**Commission économique pour l'Europe****Comité des transports intérieurs****Groupe de travail des transports de marchandises dangereuses****Réunion commune de la Commission d'experts du RID et  
du Groupe de travail des transports de marchandises dangereuses**

**Normes****Information sur les travaux en cours au CEN****Communication du Comité européen de normalisation (CEN)<sup>1, 2</sup>****Introduction**

<b>prEN ISO/DIS 17879:2016</b>	<b>Gas cylinders - Self-closing cylinder valves - Specification and type testing</b>	<b>Where to refer in RID/ADR:</b>	<b>Applicable sub-sections and paragraphs:</b> <b>Not referred in RIDADR so far</b> To be listed under closures in 6.2.4.1.
WI 00023195

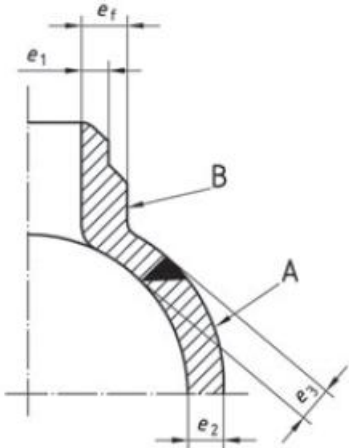
Assessment by CEN Consultant provided					
<b>Comments from members of the Joint Meeting:</b>					
Country	Clause No.	Comment (justification for change)	Proposed change	Comment from CEN Consultant	Comment from WG Standards
DT	Fig 1 (Ge)	The drawings of the typical designs of valves would benefit from a key describing the different components of the valves.	Add a key to the drawings of the valves.		
DT	5.1 General (Ge)	<i>...in indoor and outdoor environments.</i> Consider providing guidance as to what is meant by these conditions with regard to the valve being leak tight.			
DT	5.6 Leakage (Ed)	...shall not exceed 6 cm <sup>3</sup> /h The '3' should be superscript.	shall not exceed 6 cm <sup>3</sup> /h		
DT	6.1.2 (Ge)	The examples e.g. in (e) and (f) contain elements that are not in this type of valve. Spindle thread pitch, spindle, gland nut etc.	The examples should be reviewed considering these types of valves in particular.
